# **Generic Environmental Impact Statement for License Renewal of Nuclear Plants**

## **Supplement 38**

### **Regarding Indian Point Nuclear Generating Unit Nos. 2 and 3**

#### **Draft Report for Comment**

3 **Figure 4-3. Percentage of entrainment composed of RIS fish and total identified fish**  
4 **relative to the estimated total entrainment at IP2 and IP3 combined**  
5 **(data from Entergy 2007b)**

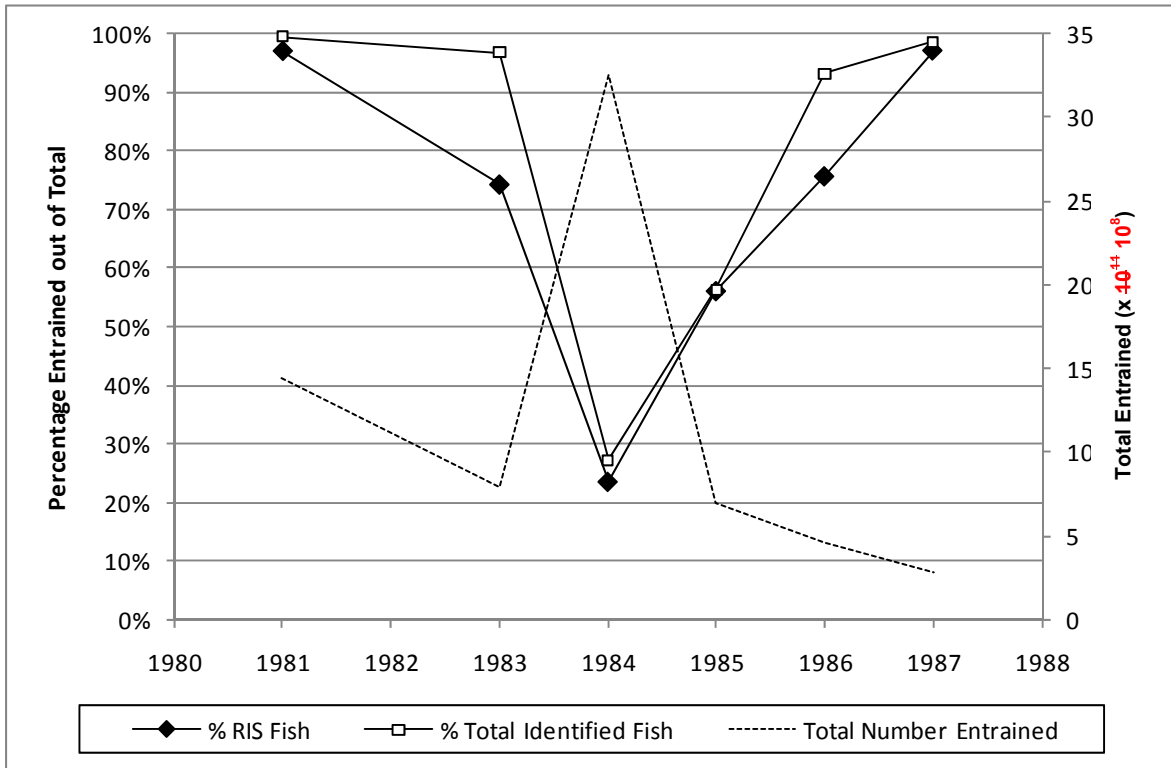
In the FSEIS, the NRC staff estimated the number entrained for a given week as the product of the mean density entrained and the combined weekly flow for IP2 and IP3. The error in the entrainment catch density directly affects Figure 4-3 in Section 4.1.2, and the error is repeated in Figure H-5 in Appendix H. In these figures, the total number entrained on the right axis should be in units of numbers  $\times 10^8$  instead of numbers  $\times 10^{11}$ . The corrected Figures 4-3 and H-5 appear below. In addition, these changes affect two portions of text in the FSEIS.

1 **Figure 4-3 on page 4-15 in the FSEIS is corrected as follows:**

3  
 4 **Figure H-5. Percentage of entrainment composed of RIS fish and total identified fish**  
 5 **relative to the estimated total entrainment at IP2 and IP3 combined**  
 6 **(data from Entergy 2007b)**

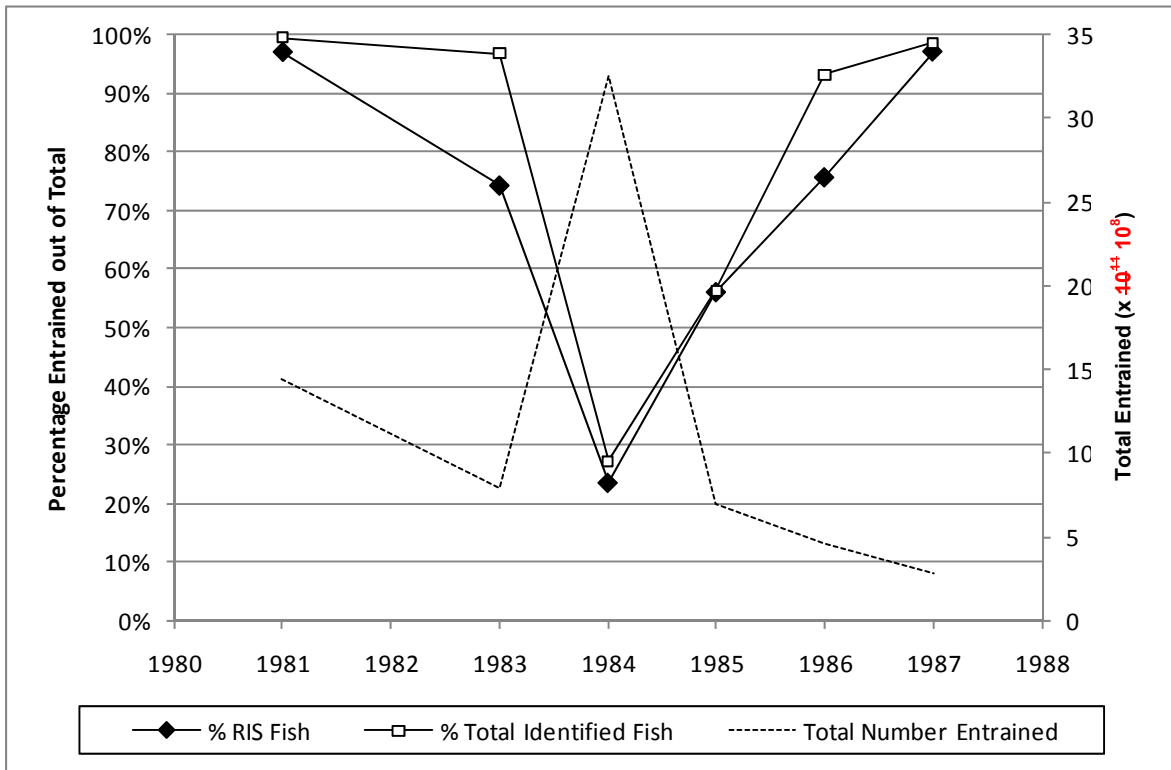
1 **Figure H-5 on page H-23** in the FSEIS is identical to Figure 4-3 in the FSEIS and is corrected  
 2 as follows:
